Exhibit 7 - Approved Design Standards Variance (Driveways Separation):

Design Standards Variance Request Form

Project Name: Latah Glen Residential Community

City Project Number (if applicable): 2023519/2023520

LOT LAYOUT

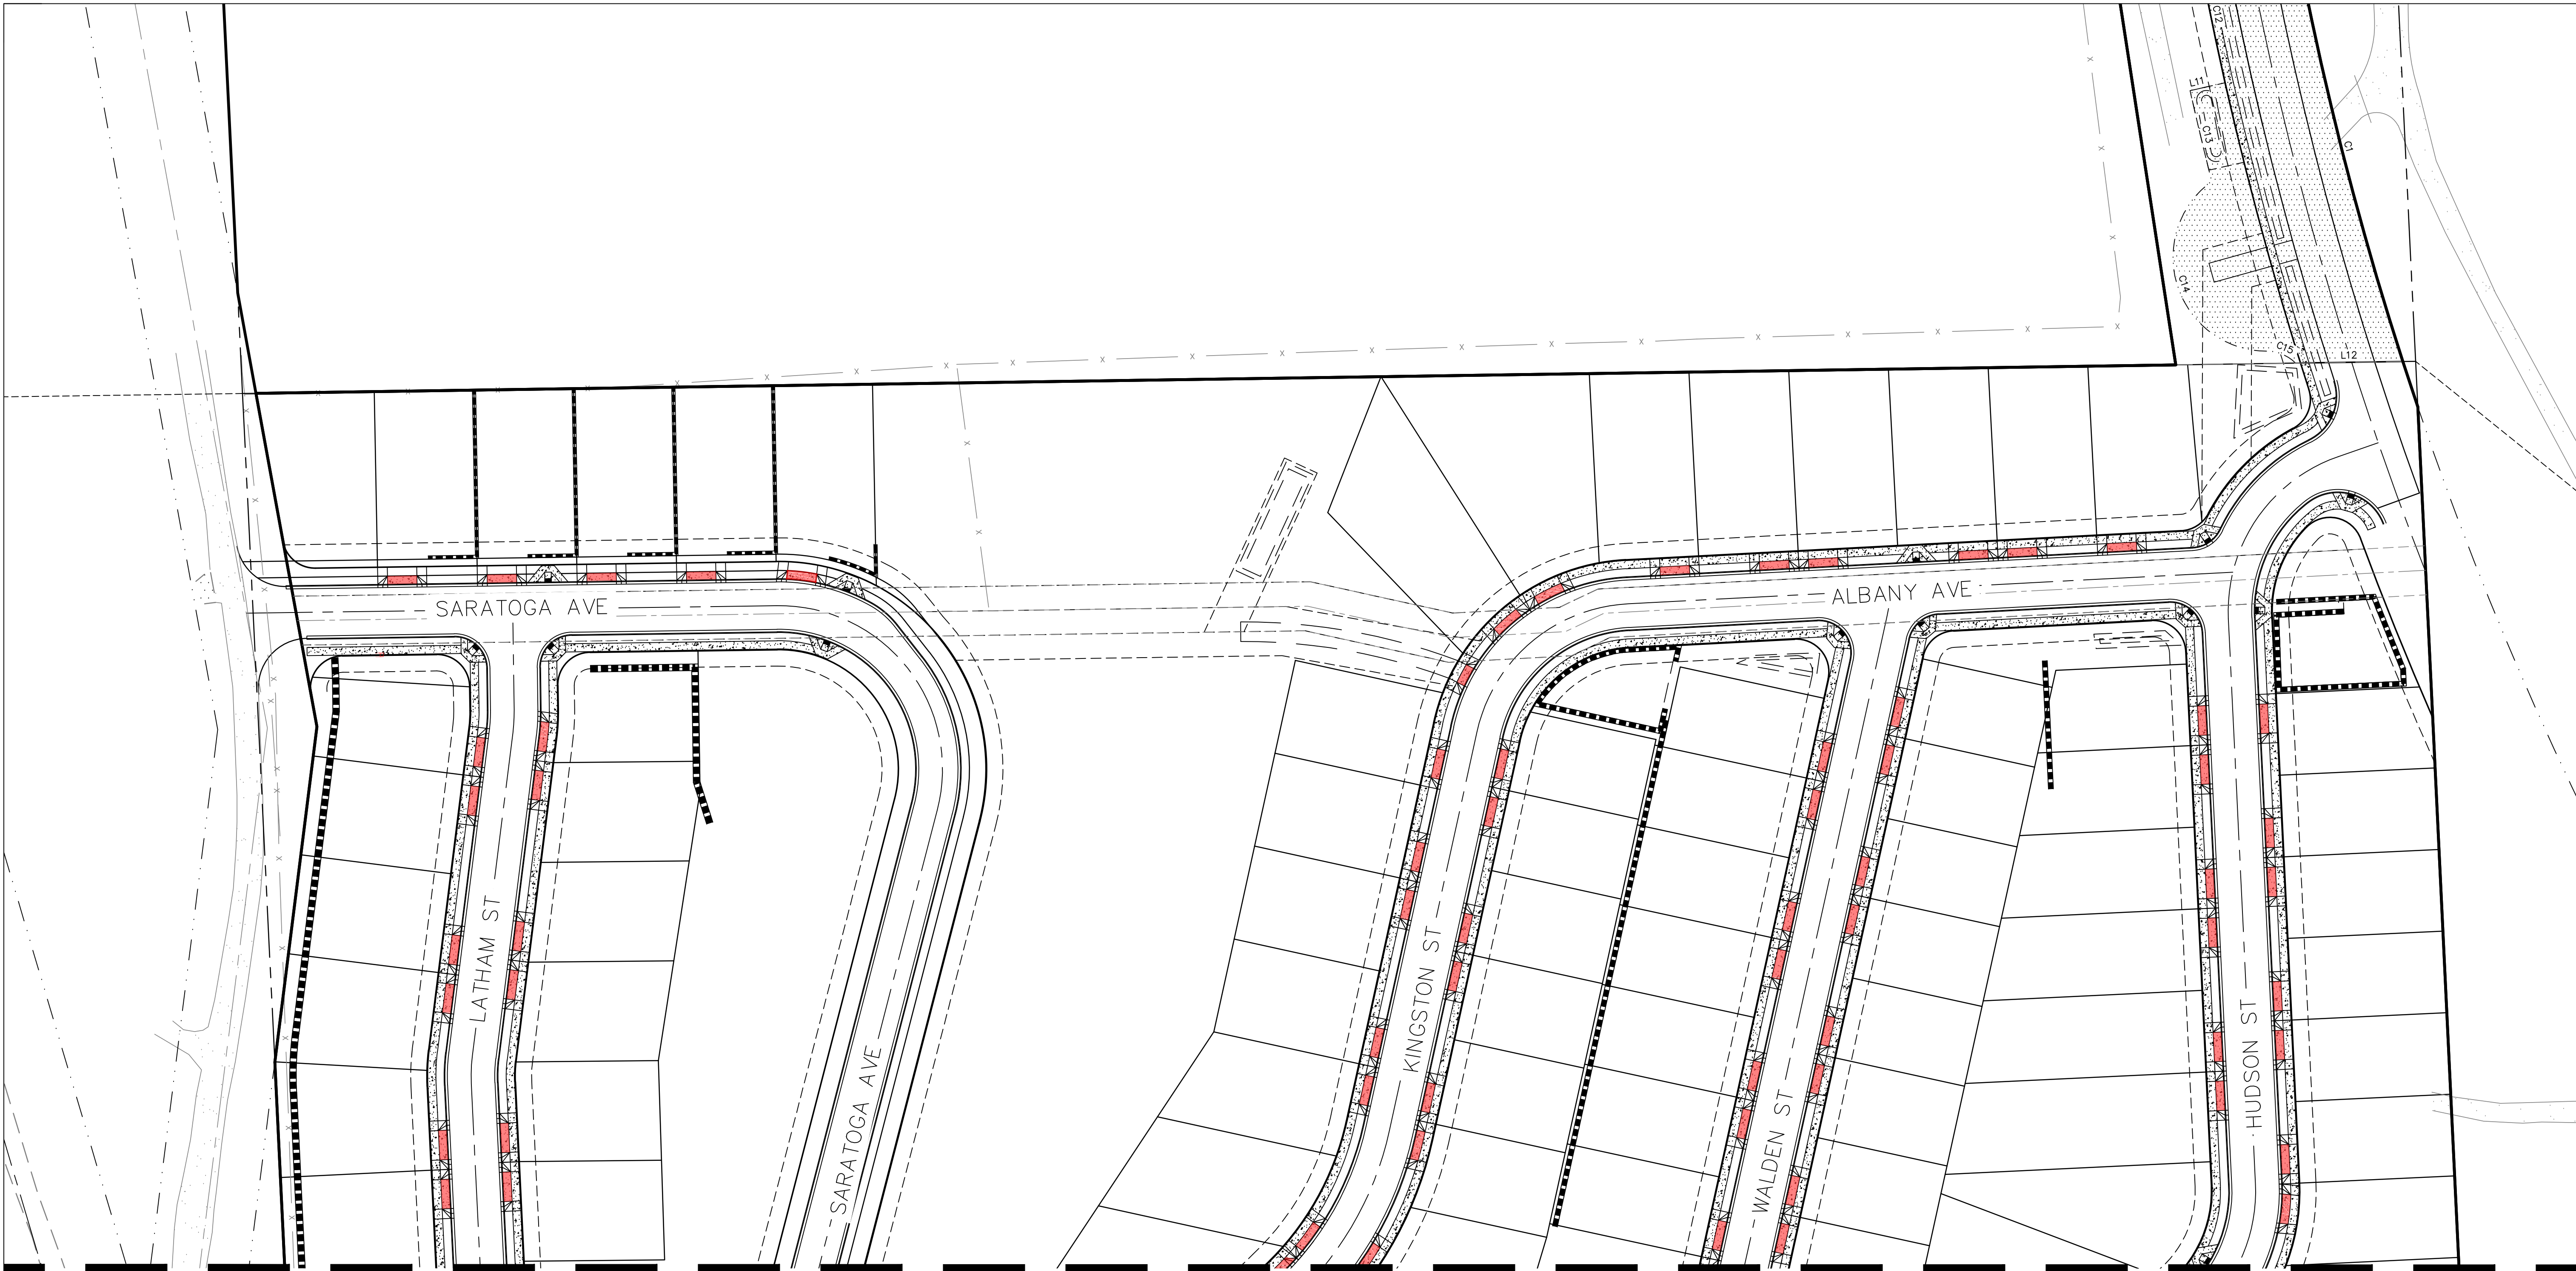
Requesting an exception for allowing less than 36' between driveways. For this project we have 50' - 62' wide lots and 18' wide driveways(excluding wings). We do not have shared/zero foot setback lot lines. We will have 12' between driveways on one side of the lots and 52'-78' on the other. Please see the attached exhibit.

Attached is a driveway separation variance request for the Latah Glen preliminary long plat. The first two attachments show the driveways in red where the separation is not met. The lot lines sheet is an exhibit related to the separation requested. Essentially, all driveways throughout the entire development are impacted by the requested variance as each grouping of two (x2) lots don't meet the minimum separation. This is where garage walls are intended to be next to each other versus living space walls lots. Please also note that the variance request figures do not account for the flares, so the approaches are actually closer than 12' (more like 2' in reality) when you accommodate the flares as per the 36' separation requirement.

Hello. I reviewed this with Melissa. Due to the topography throughout the plat I believe this qualifies for an exemption from the 36 ft requirement. Pairing the driveways as they have proposed here would be the most appropriate way to serve with vehicle access to meet the intent of 17C.111.335(C)(3)(e).

You can consider this approved from my end.
